# Meeting 6

## Hawthorns Area

### Public Comments

March 24, 2024

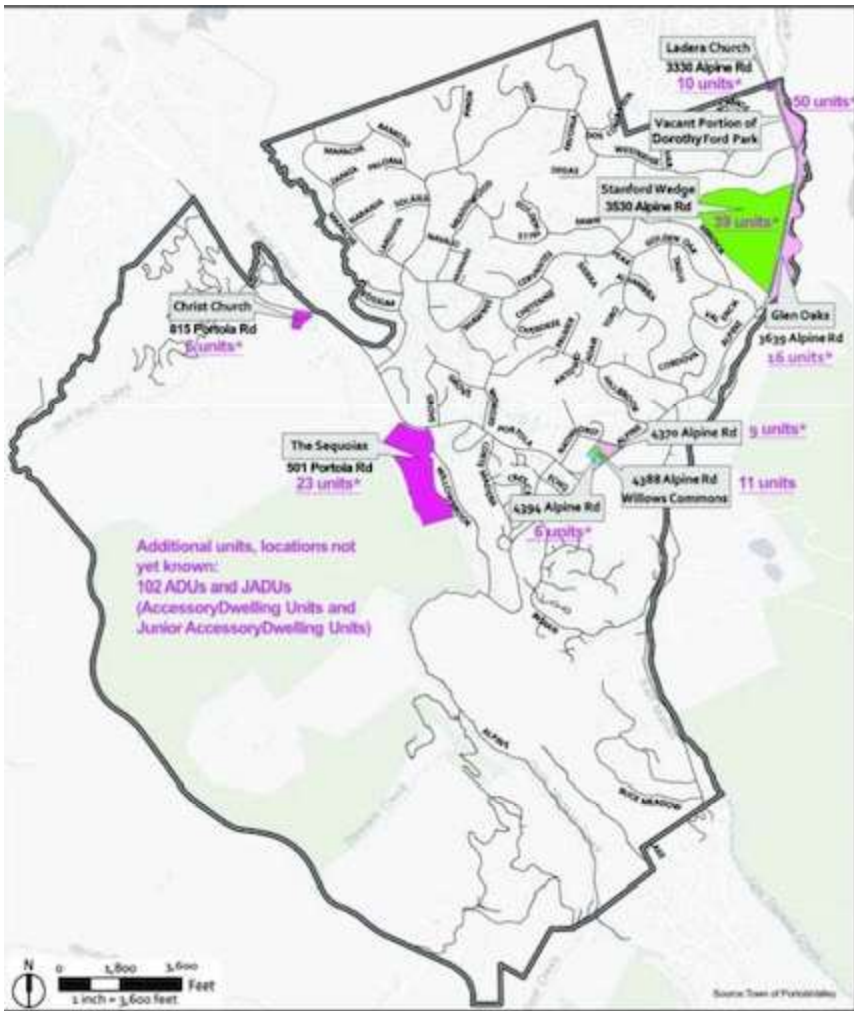
Please submit this map to the Hawthorns PAWG, traffic consultant and MROSD board of directors.

The traffic consultant said 50 units to be built on Alpine road is being planned which is incorrect.

As you can see it's much more than 50 units planned in our housing element for Portola Valley. It's over 300 units added to our community in the plan in next 7 years.

Option 10

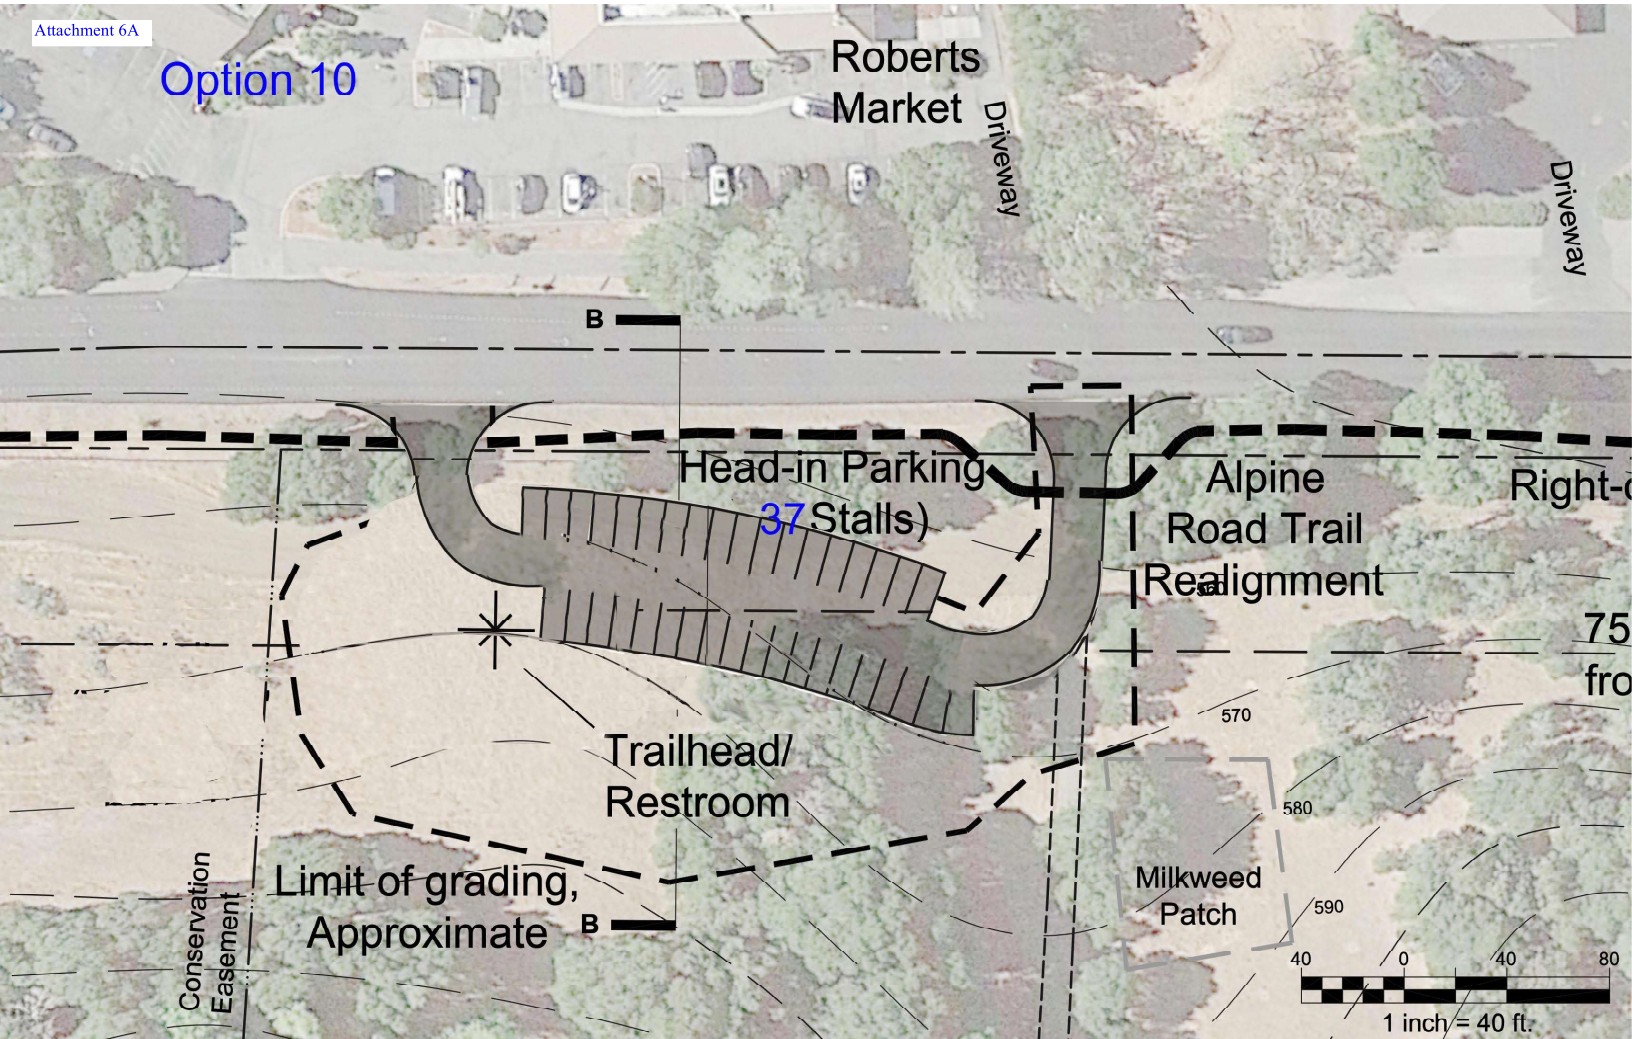
We've been looking at the packet for Sunday's meeting. We're wondering about a refined version of option 9, one that would eliminate the need for the "turning bulb" and replace it with an additional driveway farther to the west.

## Hawthorns Parking Plan #9A:

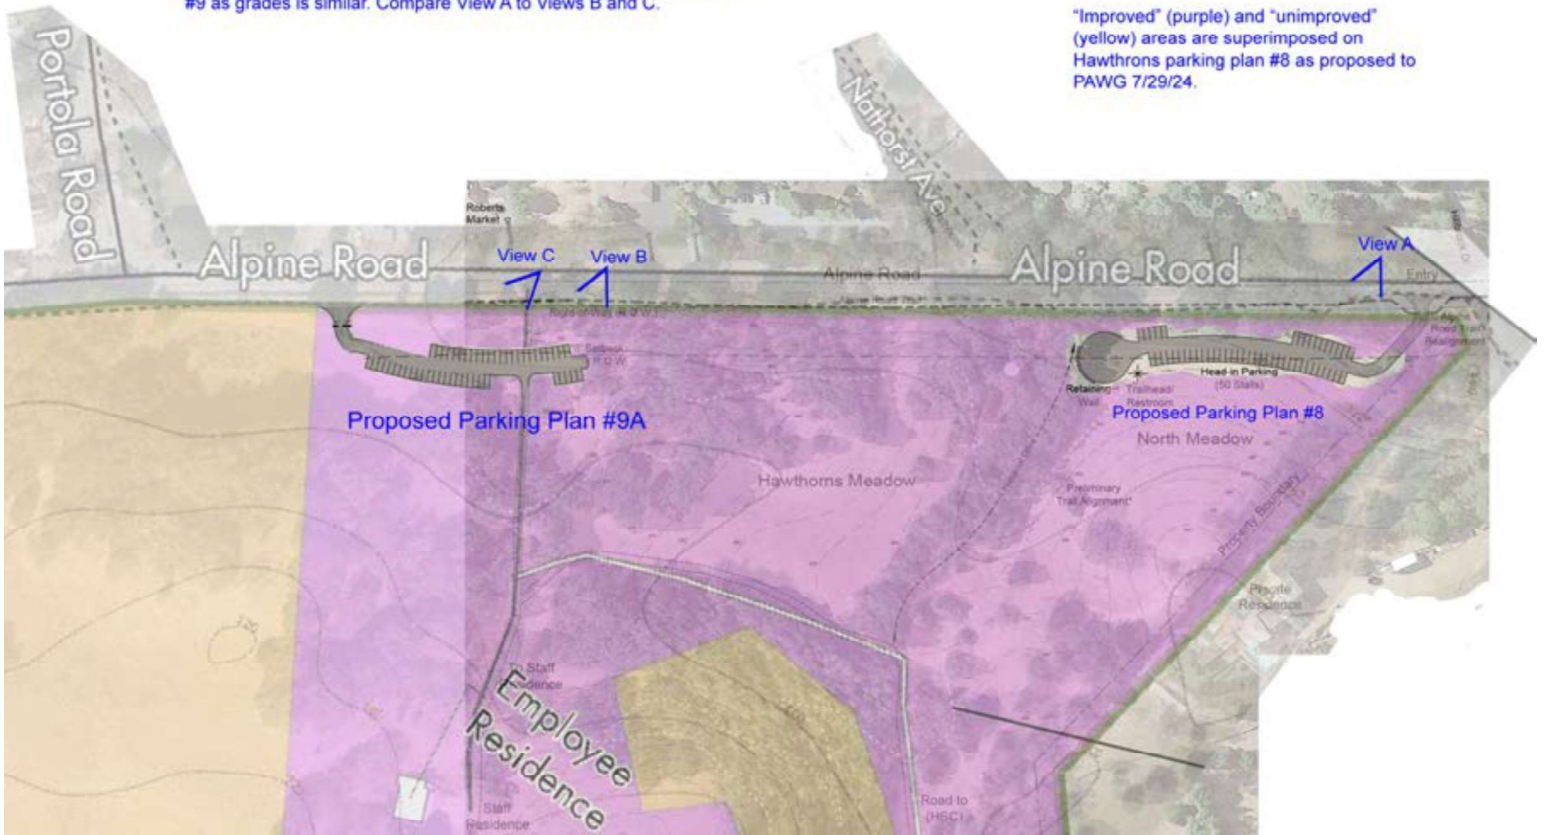
We have done some further investigation into parking options and would like to propose options 9A and 9B for consideration. It does seem that we can get the desired number of parking spaces outside the area covered by the conservation easement. These options avoid the safety issues associated with #8 and the natural resource concerns with #7. We also believe that the parking would be visually equivalent to #8 and could be mitigated with screening planting.

"Improved" (purple) and "unimproved" (yellow) areas are superimposed on Hawthorns parking plan #8 as proposed to PAWG 7/29/24.

## Hawthorns Parking Plan #9B:

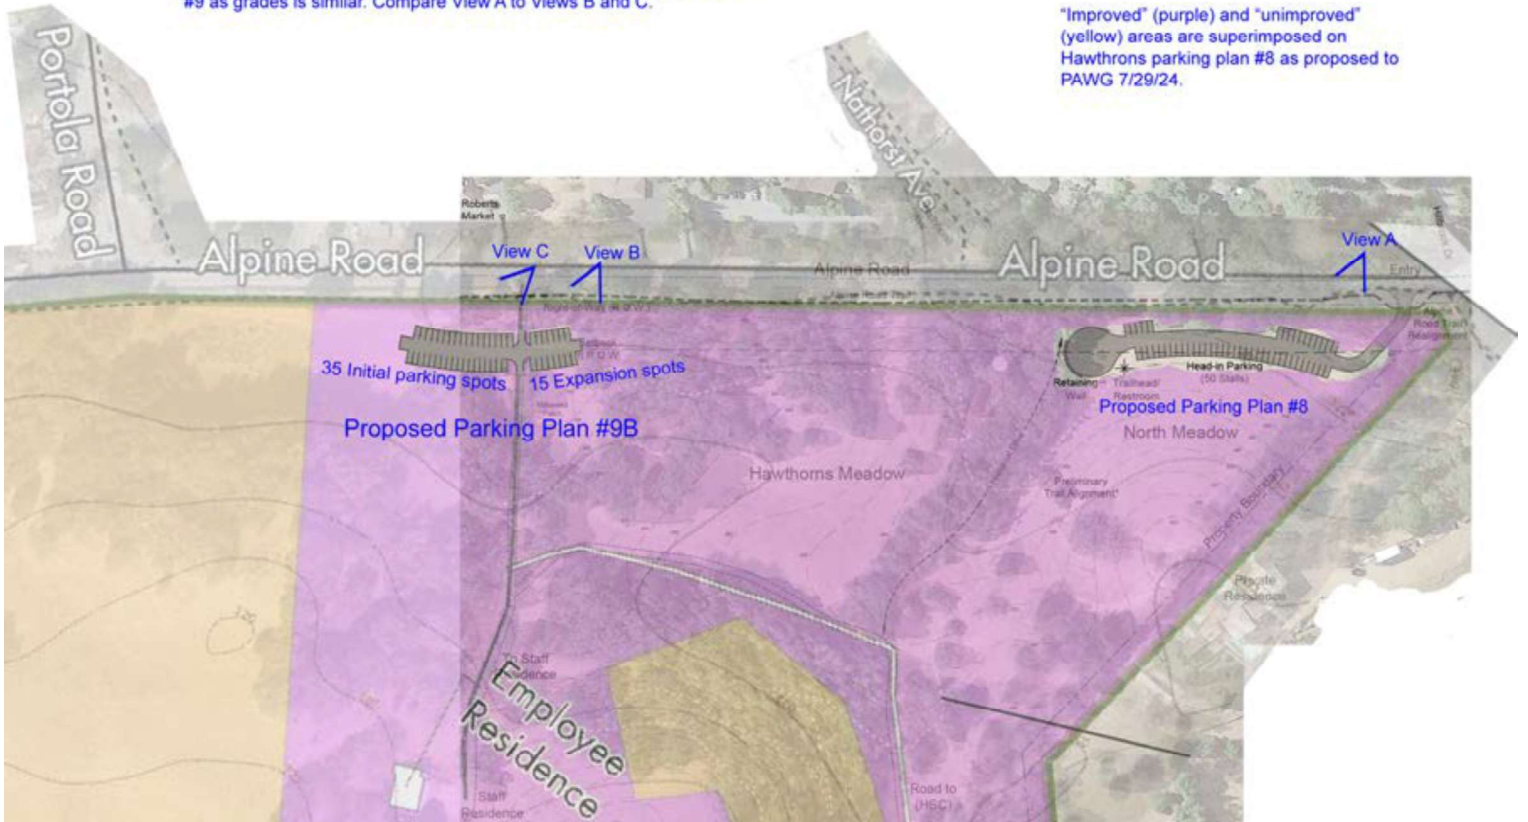
- Preserves the Hawthorns Meadow
- Entrance retained at current location
- Improvements are all in "Improved" area
- 50 Parking spots
- If #8 could be "below grade" enough to be hidden from Alpine, so can #9 as grades is similar. Compare View A to Views B and C.

"Improved" (purple) and "unimproved" (yellow) areas are superimposed on Hawthorns parking plan #8 as proposed to PAWG 7/29/24.

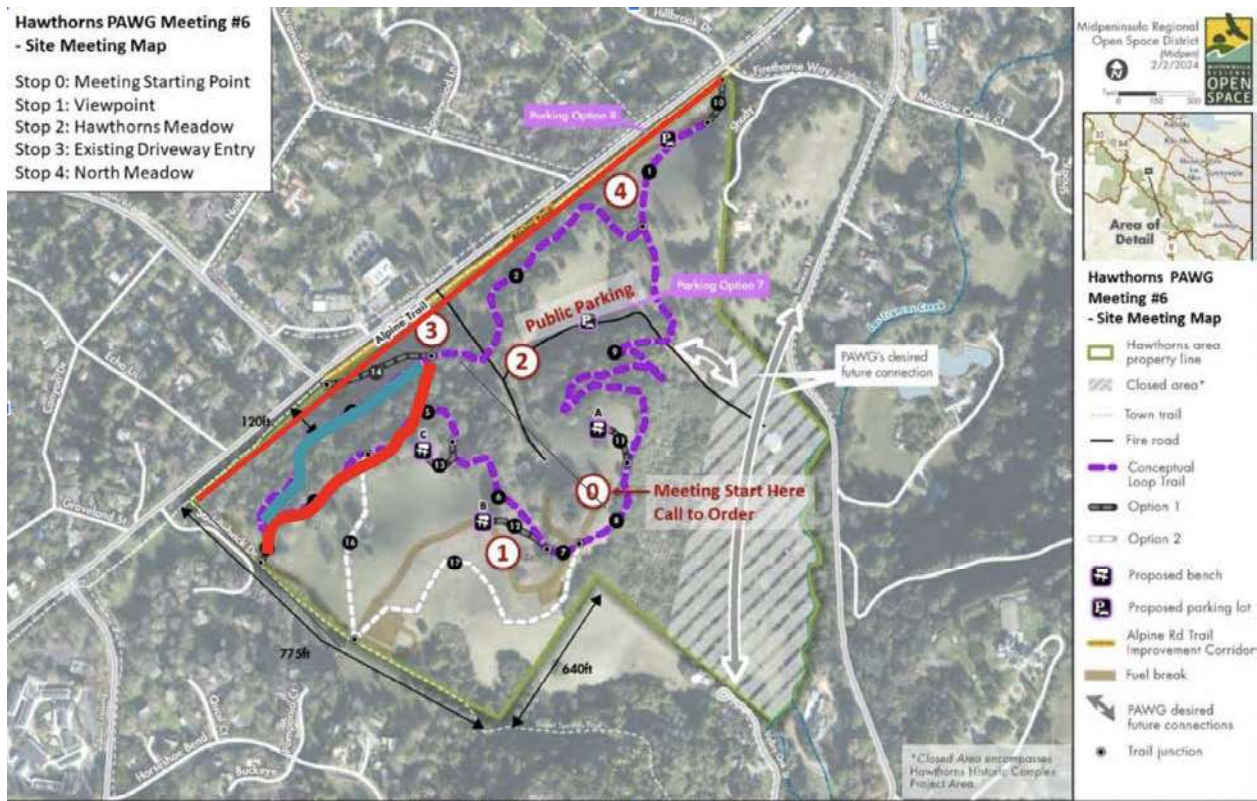
- Parking Site 8 is adjacent to a small unmarked stream<sup>1</sup>. Please recommend removing it from further consideration as a parking area.

<sup>1</sup> Please add this stream to the Existing Condition report and maps.

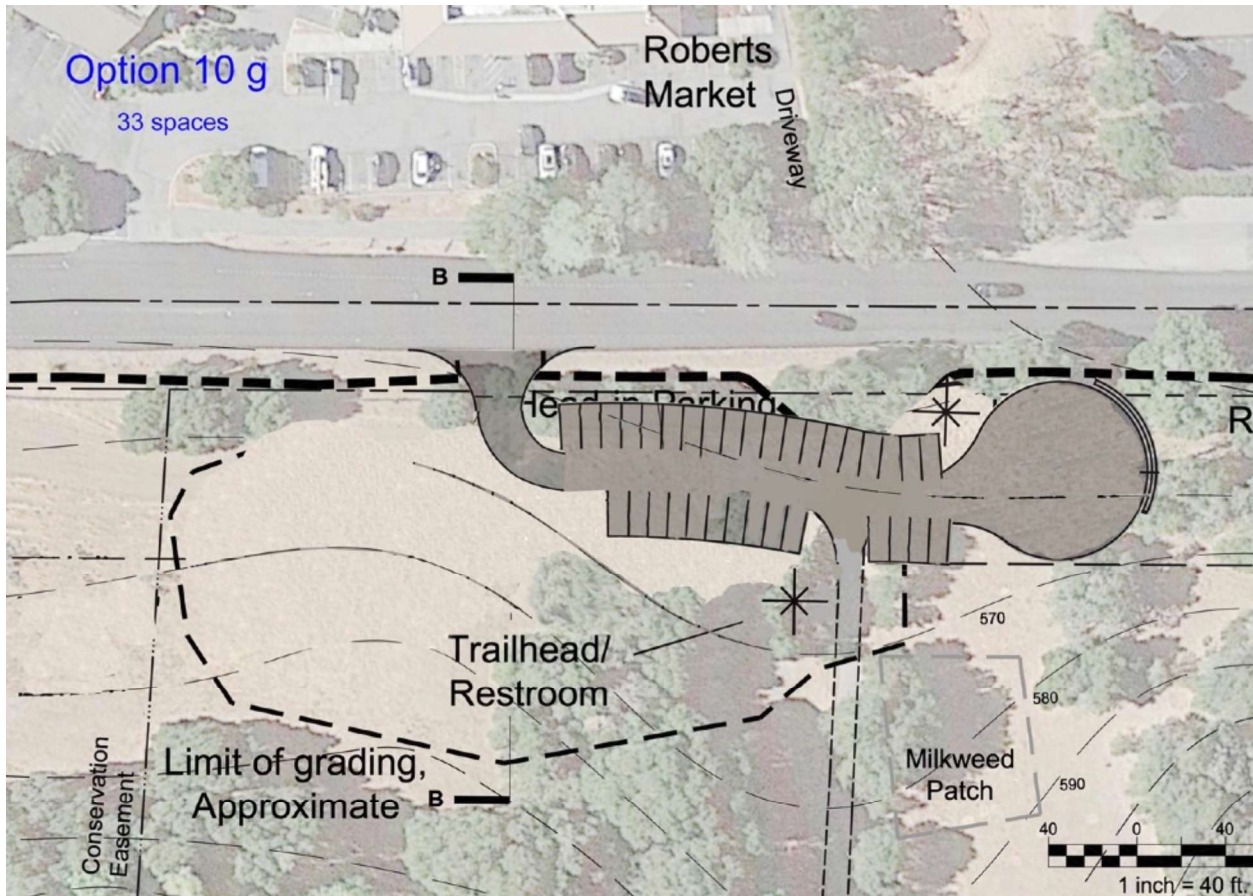
Question: Does the turn around need to be flat or nearly flat?

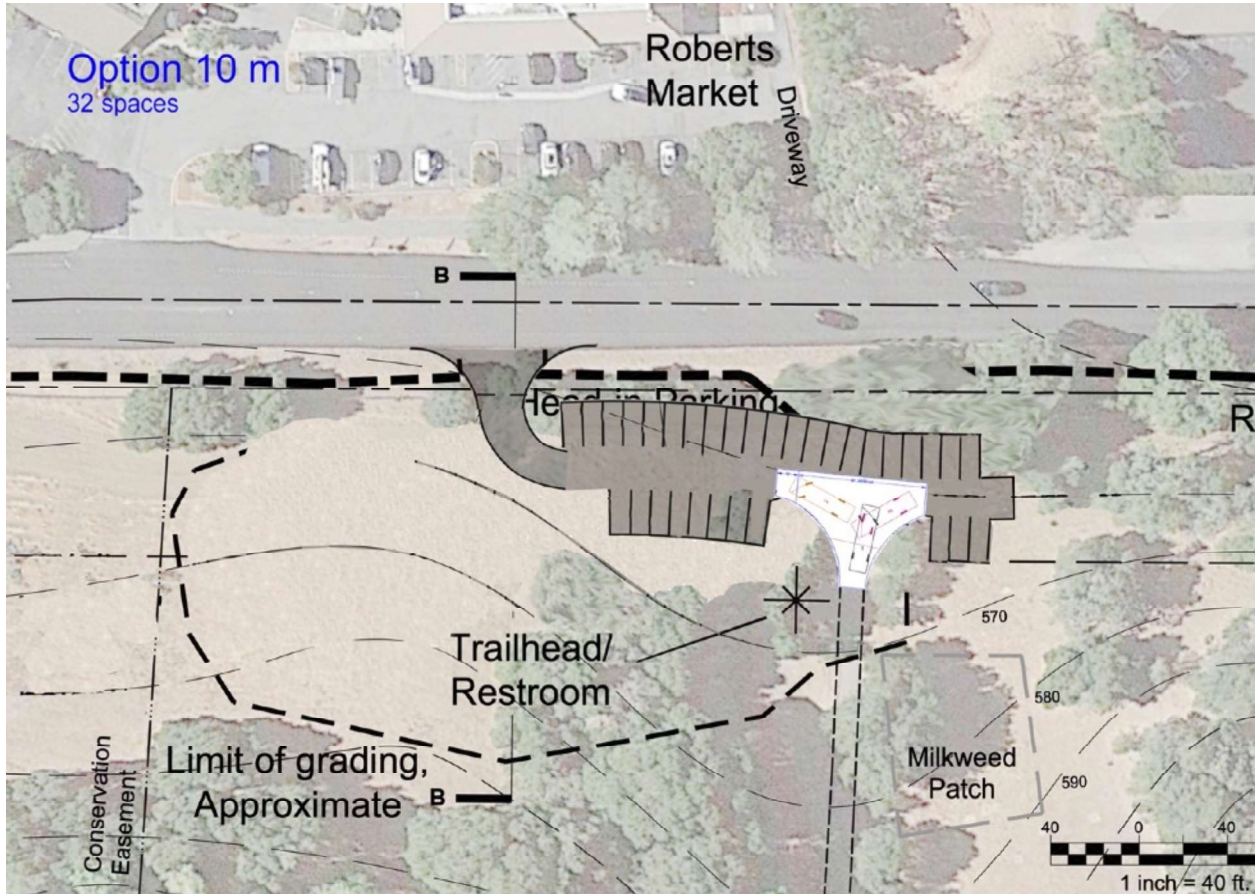
Option 10 M incorporates a turn around design built by The Los Trancos County Water District in cooperation with Woodside Fire around 2010. The geometry of the “hammer - head” shown below met their requirements then, but the Fire Marshal should probably be consulted if we want to propose something like this.

Pluses	Minuses
Lowest impact? Requires least amount of grading	“Hammer head” turn around may not be acceptable as it’s not as easy to use as the 80’ conventional turn around

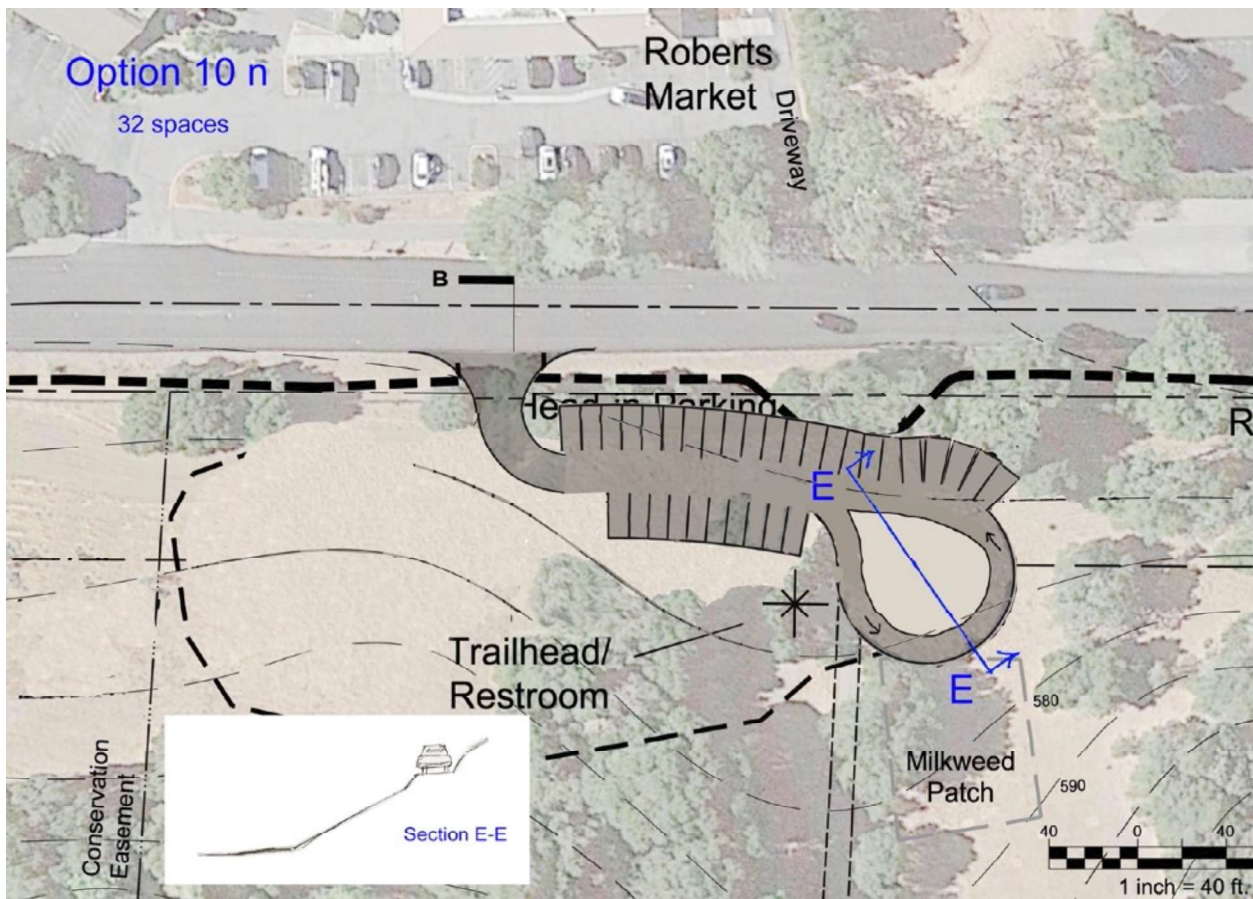
If the “Hammer-head” approach is not acceptable, and we must have an 80’ diameter turnaround, does the it need to be flat?

This design uses a “Turn around Road”. Section E-E shows how road could partially climb on the hillside above the lot.
